48076 In Line Fuel Filter, install at inlet side of fuel lift pump.

Products manufactured prior to December 2002 do not have this filter.

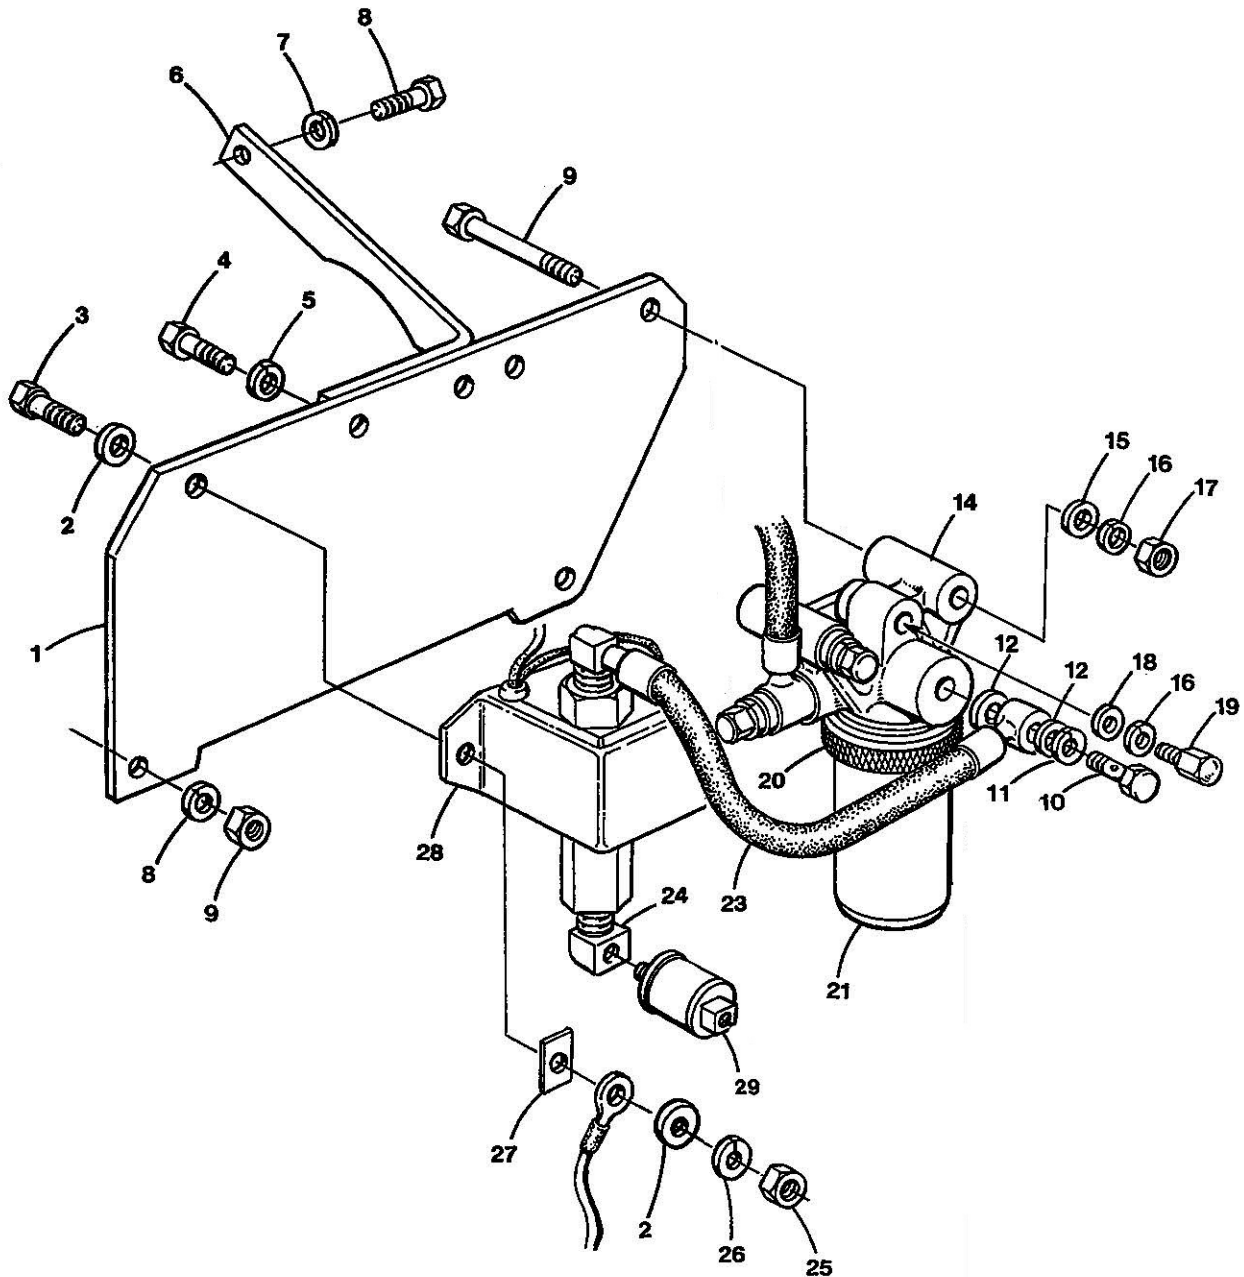
Reference 29 below is a good example of inlet location.

This 80 Micron filter was added to protect the lift pump on new installations.

Installation of filter, if you choose to, is best left to a trained profesional.
